WASHINGTON AVENUE

PROPOSED WEST ELEVATION
SCALE: 1/4" = 1'-0"

REVISED SUBMITTAL 9/25/08
 REVISED AS PER 3RD CITY OF MIAMI BEACH REVIEW
 REVISED SUBMITTAL 9/1/08
 REVISED AS PER 2ND CITY OF MIAMI BEACH REVIEW
 REVISED SUBMITTAL 5/21/08
 REVISED AS PER CITY OF MIAMI BEACH REVIEW

230 FIRST STREET

PROPOSED SECTION A-A
SCALE: 1/4" = 1'-0"

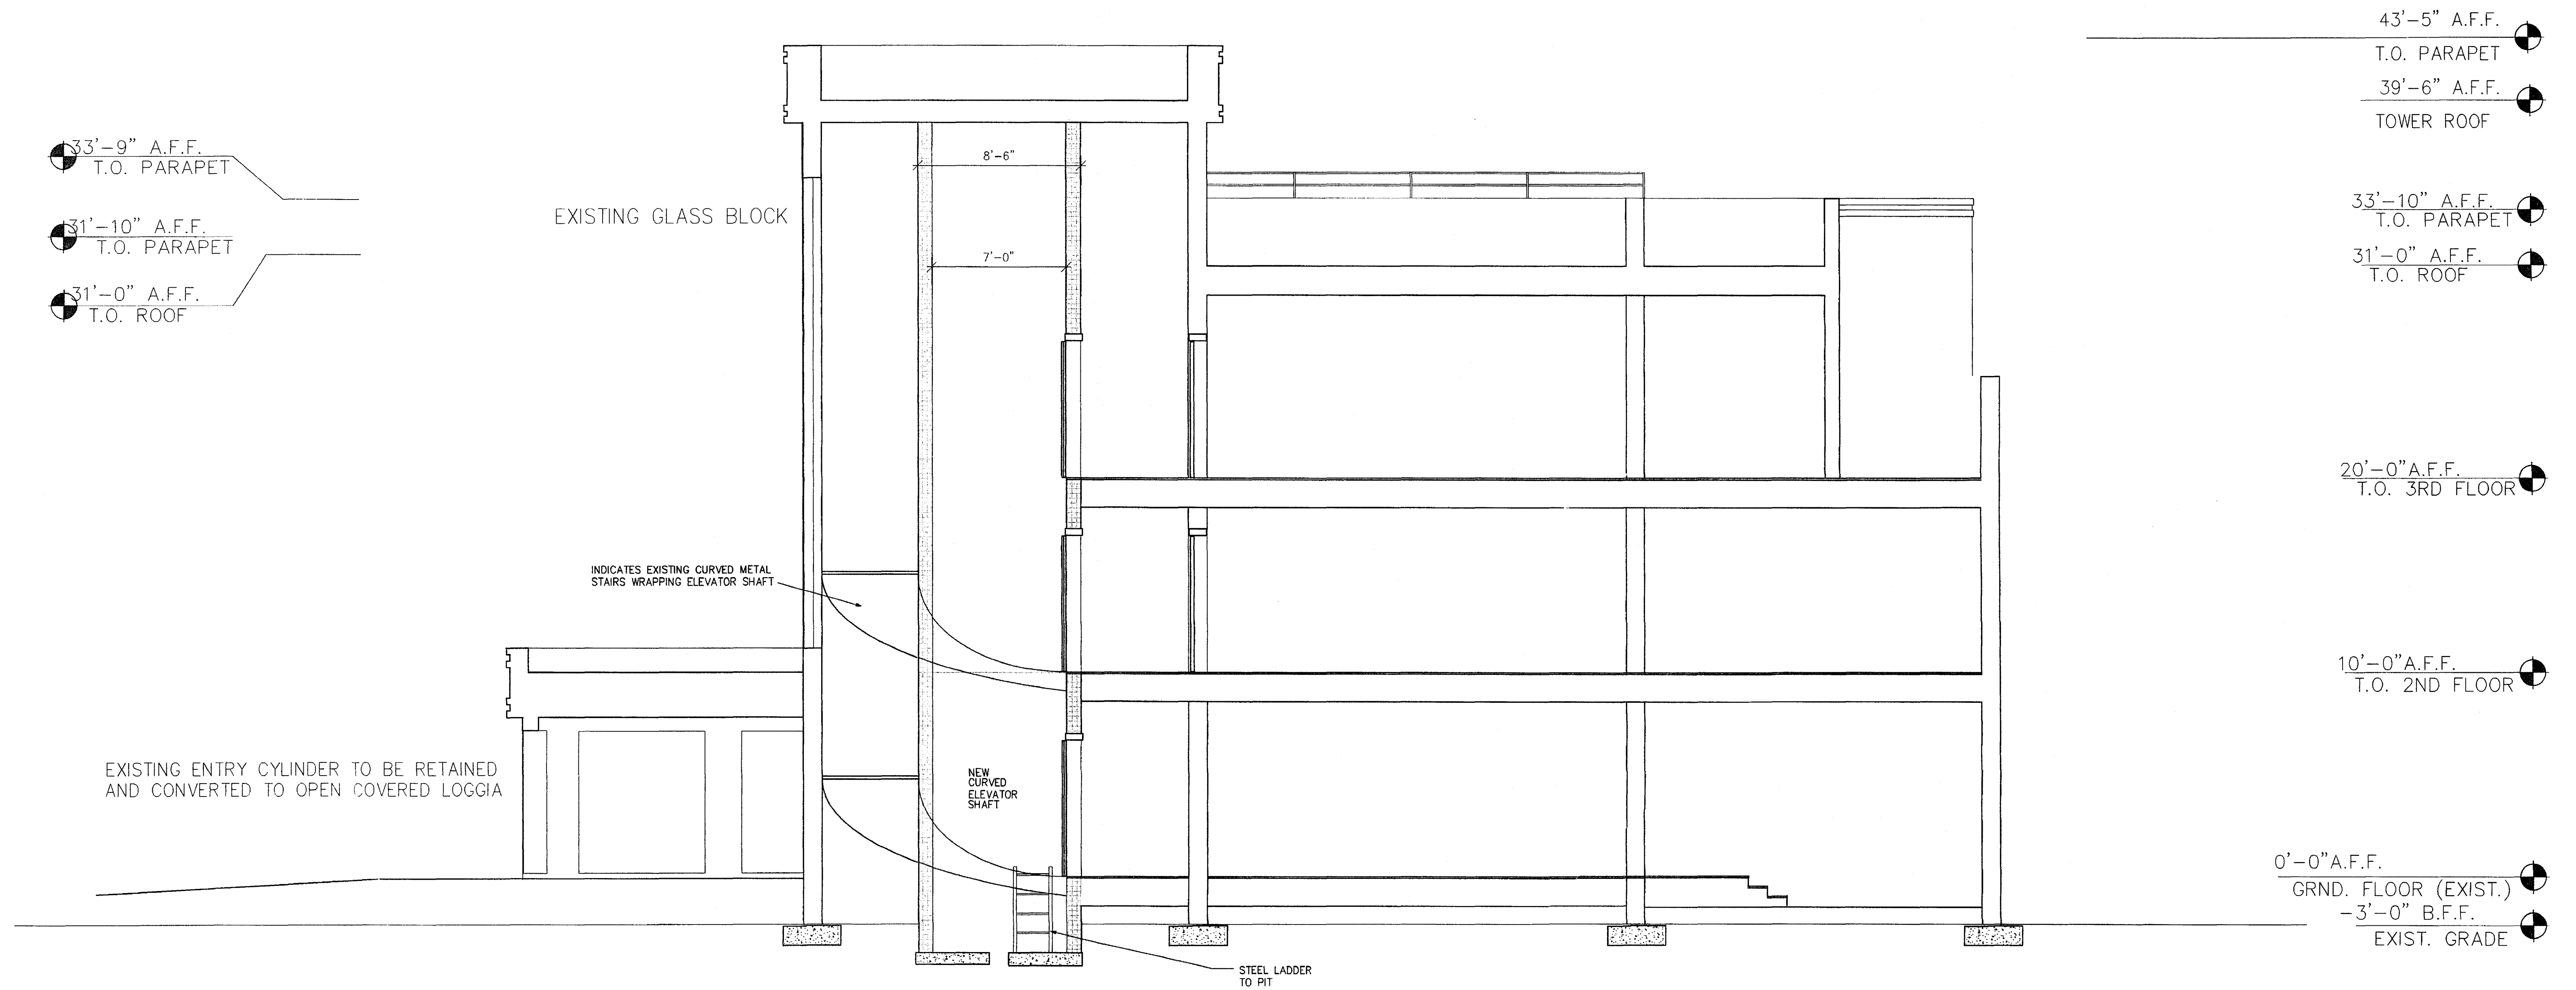
RAILINGS REVISED/CANOPY DELETED AS PER HPB
